# 3812 - Addendum 1

To	Kristen Haskell	Date	10/03/25
For	Long Creek Youth Development Center Ceiling Replacement	Project No.	BGS# 3812 SMRT# 25014

This addendum forms a part of the bidding and contract documents.

12 EXISTING CONDITIONS PHOTO (TRIAGE HUS121)  
NTS

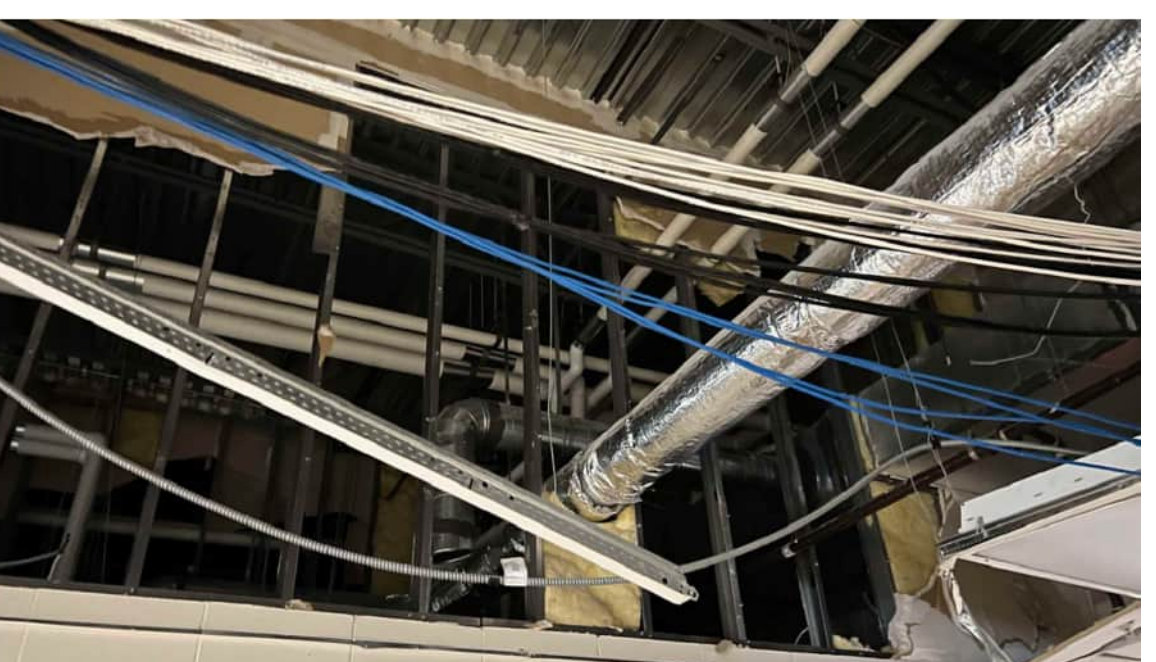
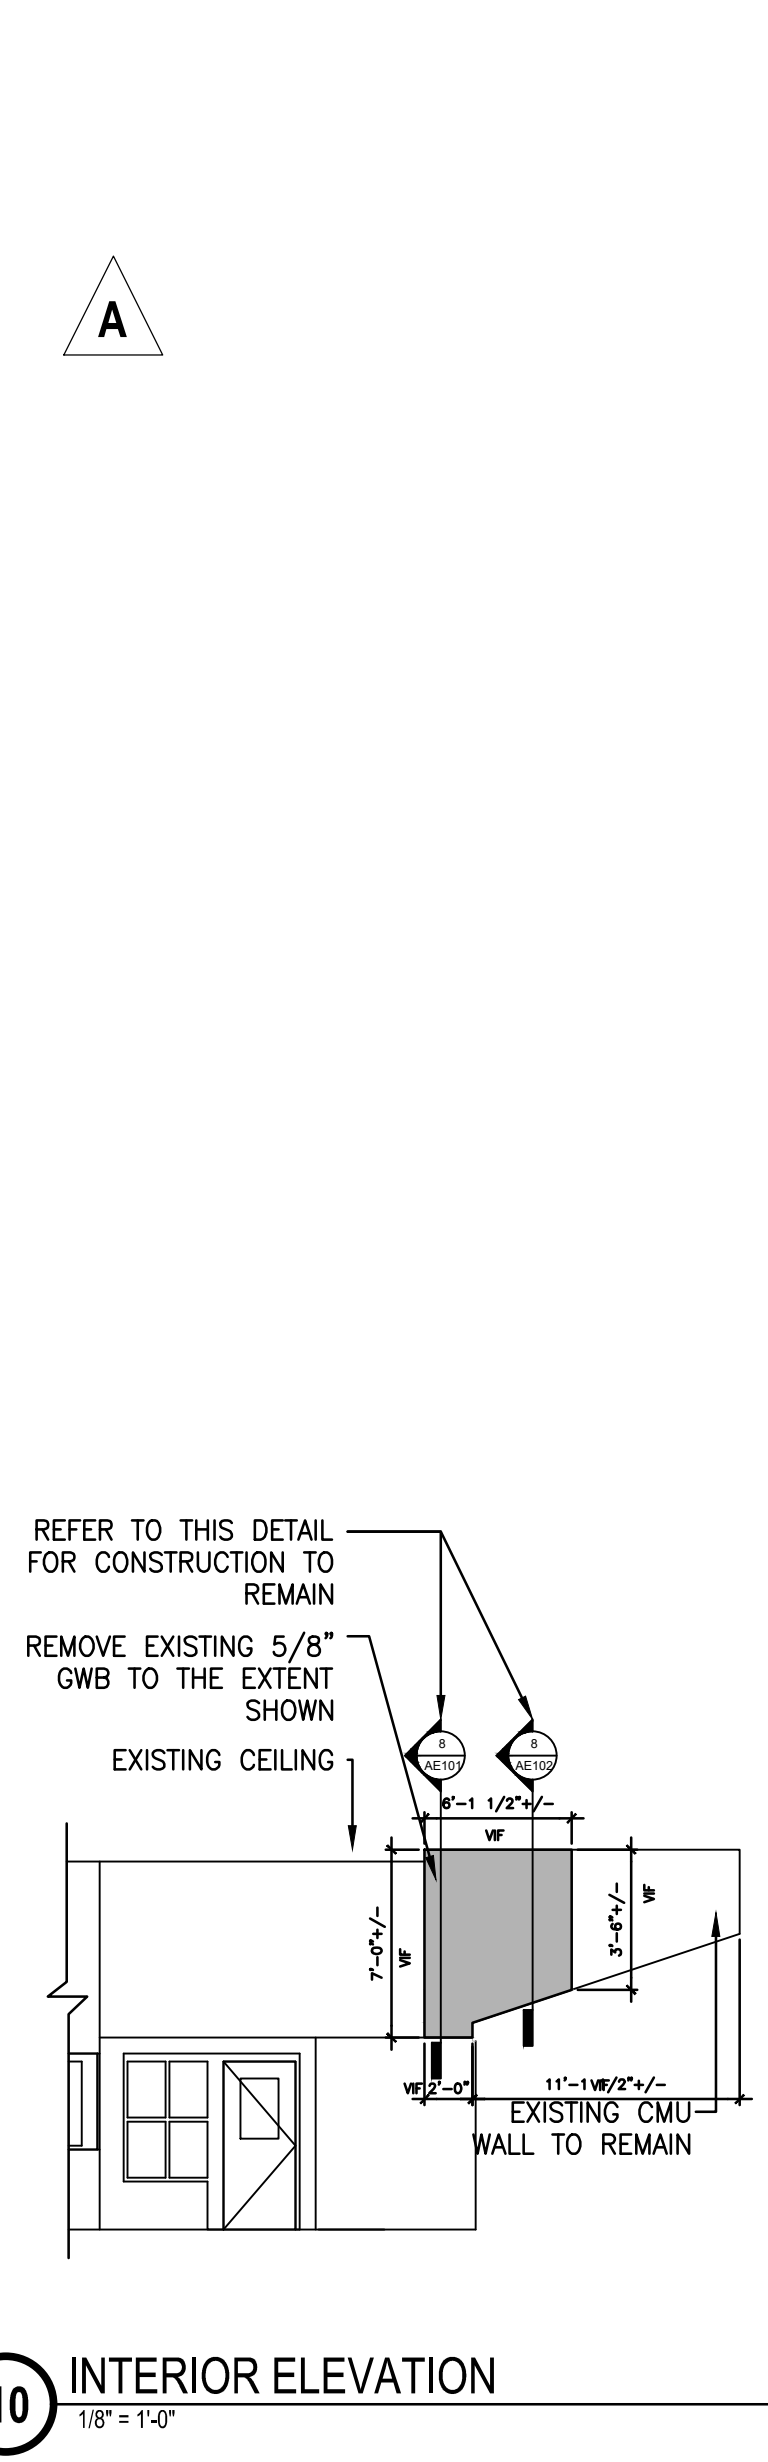
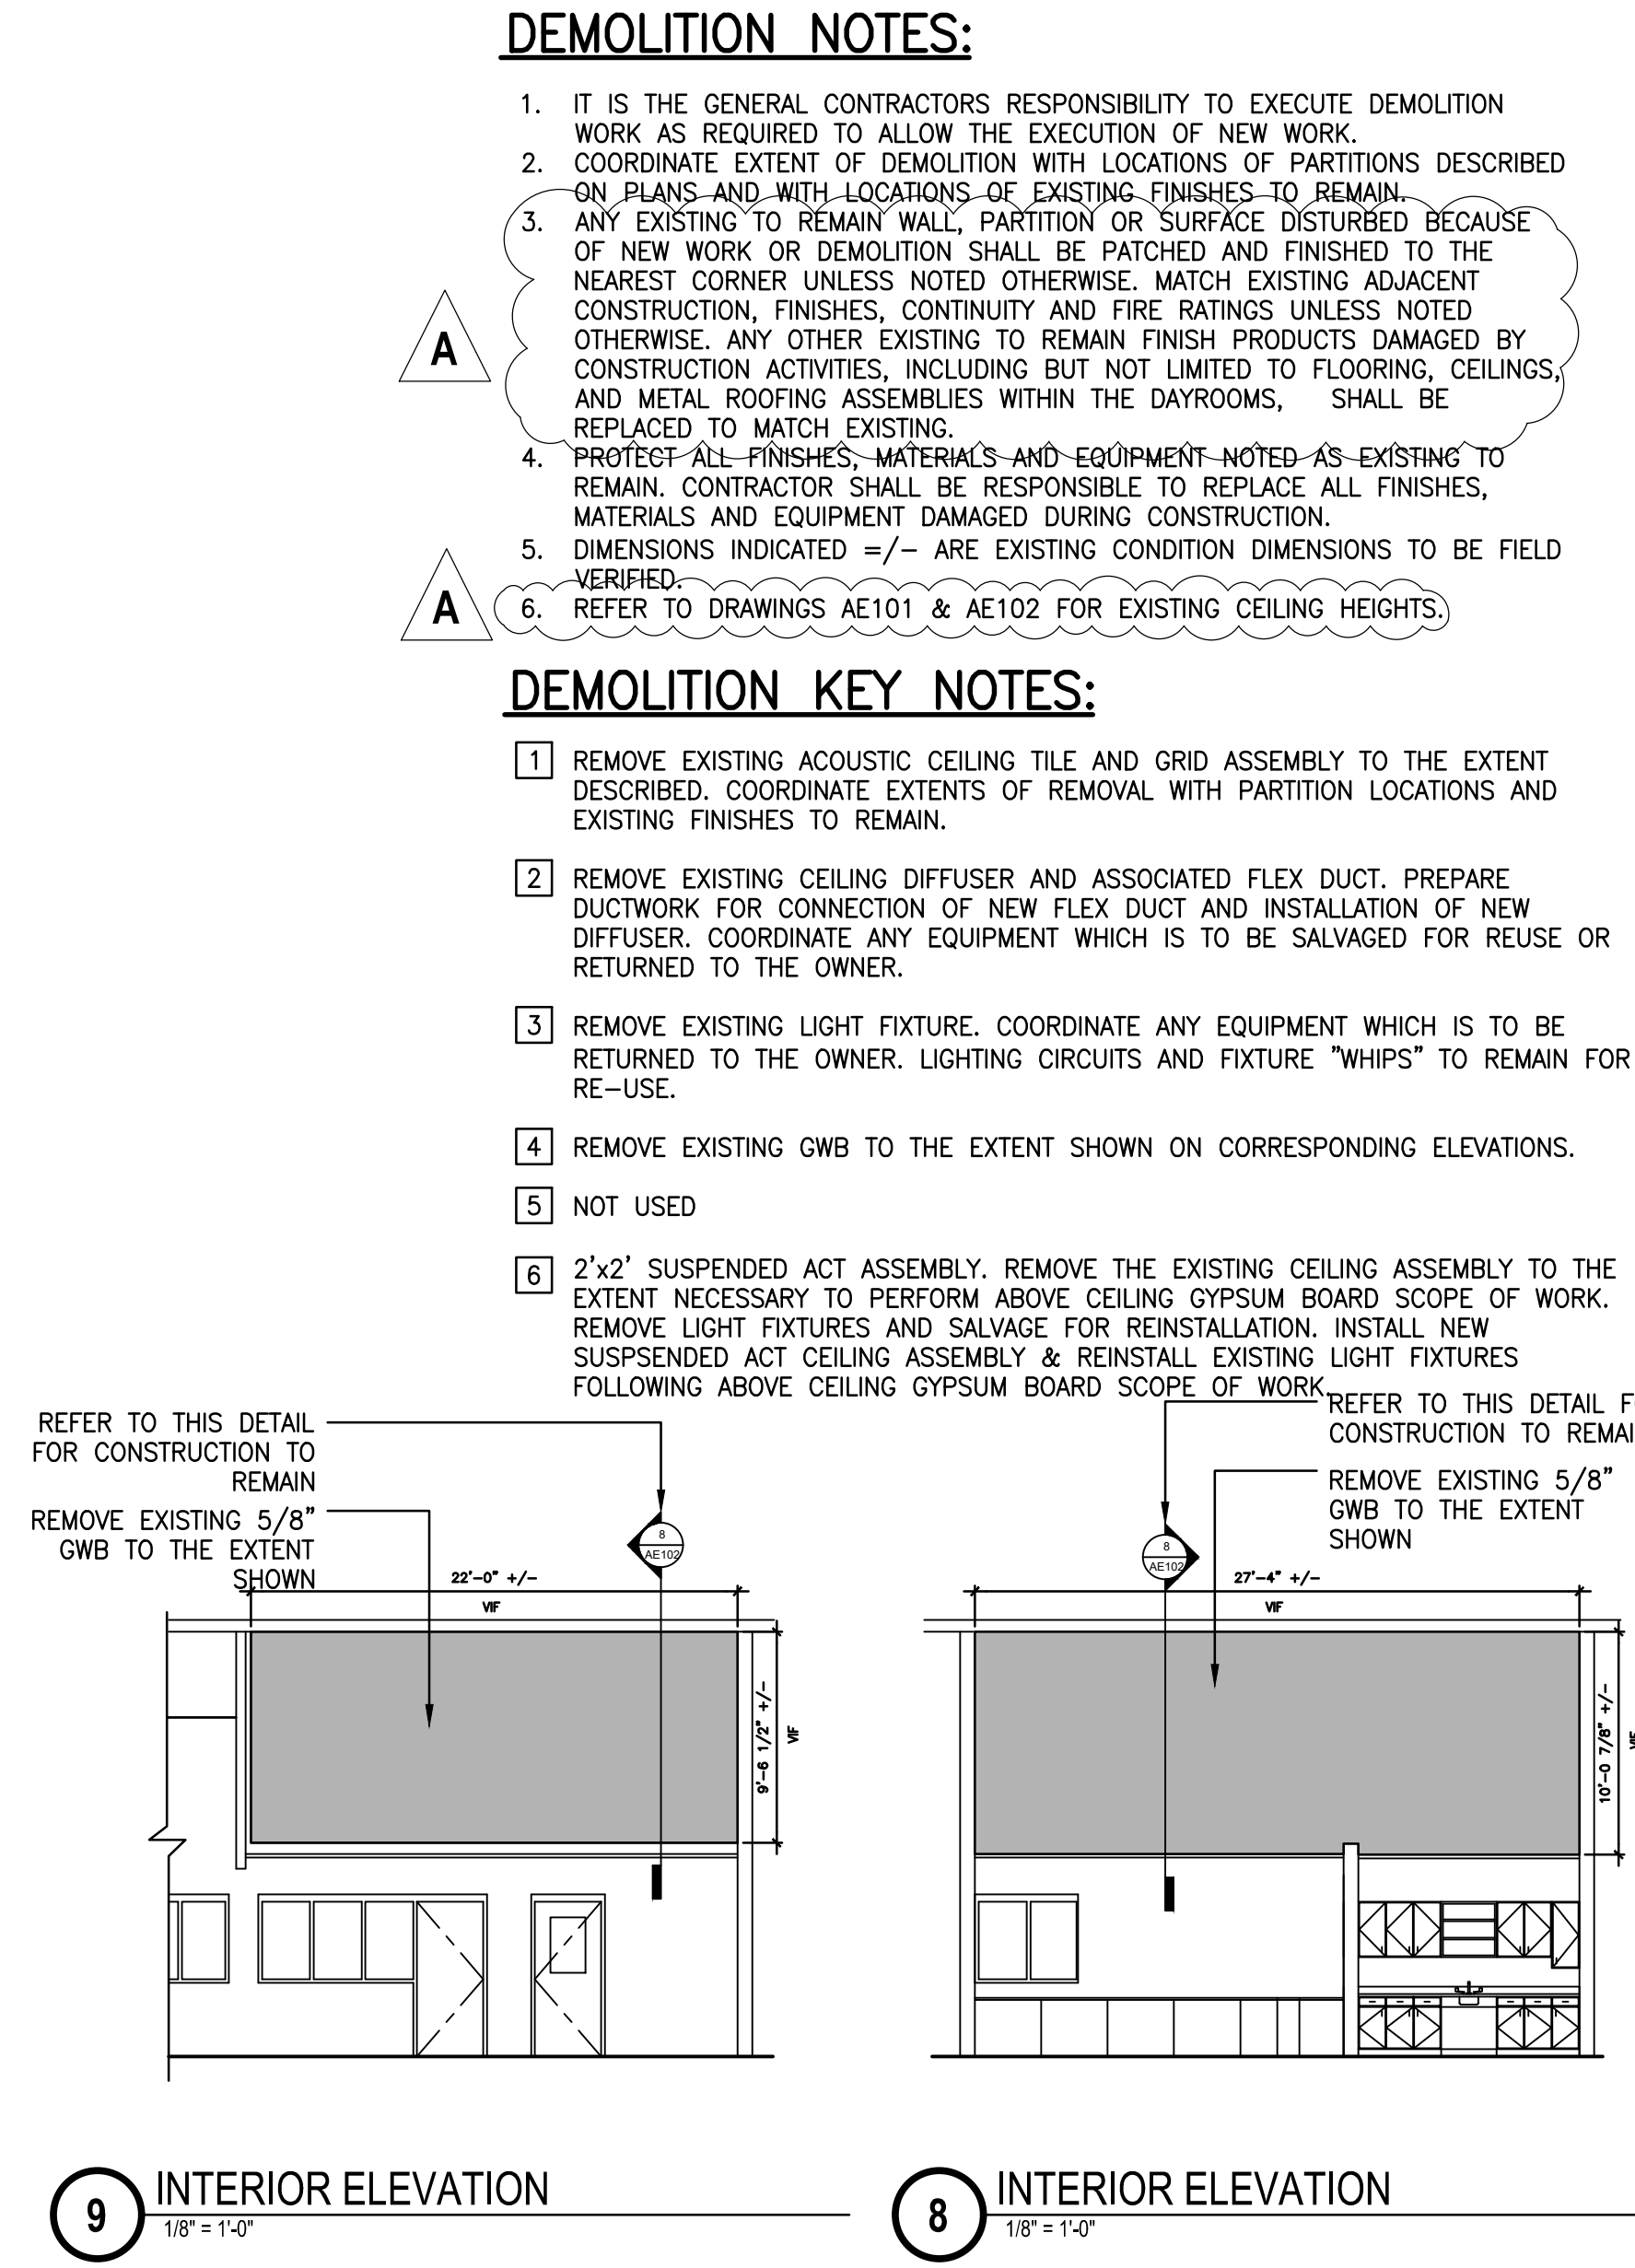
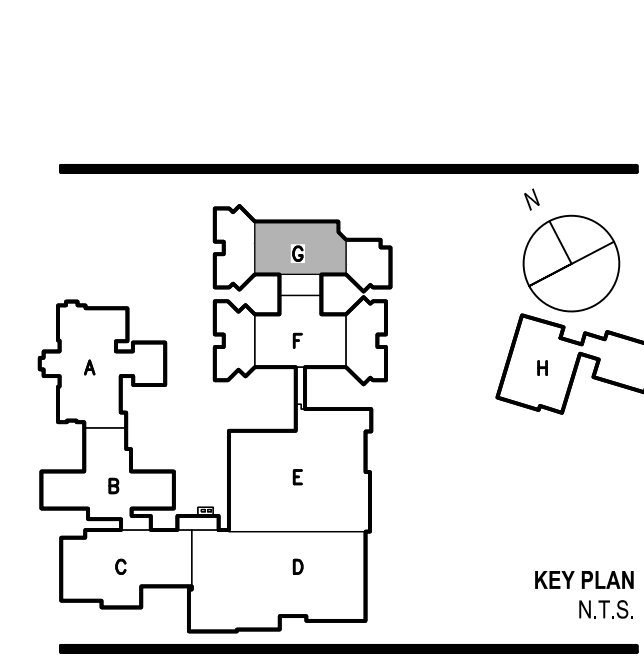
<b>The project will start immediately following a fully executed contract, which can't be predicted. For bidding purposes, assume 2 weeks following the date of bid opening. The project substantial completion and final completion dates are indicated in project manual section 00 11 13 "Notice to Contractors".</b>
Q13.	The specs do not include spec section 014100 Special Inspections. Please confirm there are no special inspections required. RESPONSE: <b>Confirmed.</b>
Q14.	Please confirm the contractor is not responsible for permitting. RESPONSE: <b>The contractor is responsible for building permitting.</b>
Q15.	Is there any hazardous or contaminated materials that will be encountered during construction? RESPONSE: <b>None that we're aware of or anticipate being encountered.</b>
Q16.	On the drawing AD102 there are spaces for existing photos, can these be provided? RESPONSE: <b>Refer to the attached revised drawing AD102 for photos.</b>
